Rezoning Transportation Analysis

Petition Number: 2020-134

Date	Description
10-20-2020	First Review (KP)
11-30-2020	Second Review (KP)

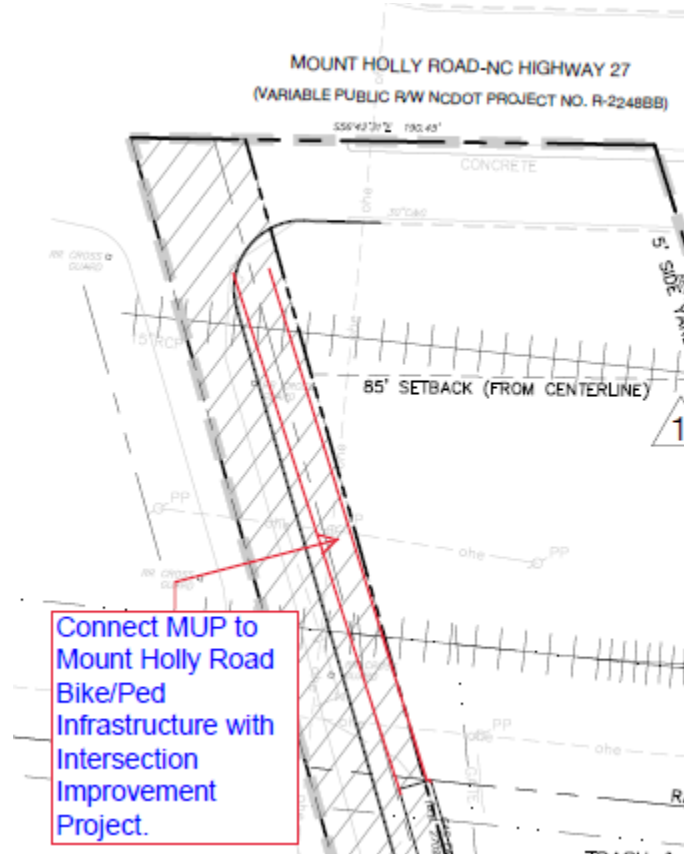
3. Right-of-Way Dedication:

- a. **Mt. Holly Road:** Revise the site plan and conditional note(s) to commit to dedicate 55-feet of right-of-way from the road centerline. **Update as a result from 11-16-2020 Site Plan: Dedicate as much ROW as possible without encroaching into the Railroad ROW.**
- ~~b. **Rhyne Road:** Revise the site plan and conditional note(s) to commit to dedicate 41-feet of right-of-way from the road centerline. **Update as a result from 11-16-2020 Site Plan: 40-feet of ROW dedication is acceptable.**~~

The site plan should label and dimension the right-of-way from the road centerline.

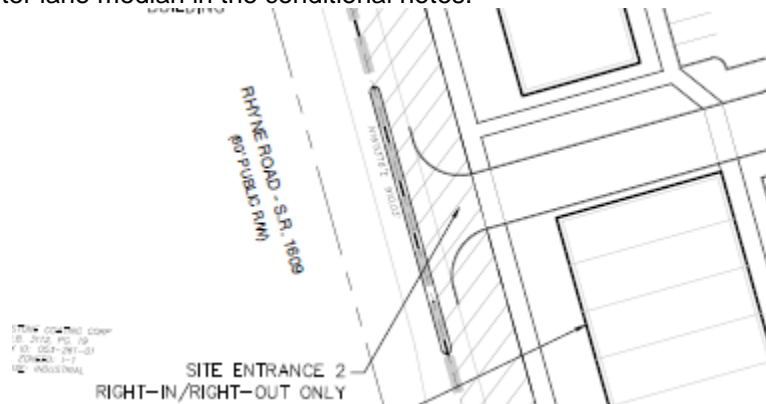
4. Revise the site plan and conditional note(s) to commit to construct an 8-foot planting strip, and 12-foot multi-use path along the site's Mt. Holly Road and Rhyne Road frontages per Chapter 19 and the City's WALKS and BIKES policies. The site plan should label and dimension both items from the back of curb and gutter and road centerline.

Update as a result of the 11-16-2020 Site Plan: Add a conditional note stating that the 12-foot MUP will be extended across the railroad and connected to the bicycle pedestrian infrastructure constructed as a part of the Mount Holly-Sonoma Valley/Rhyne Road Intersection Improvement Project. This MUP connection will coincide with the intersection improvement project and will be coordinated with NCDOT.
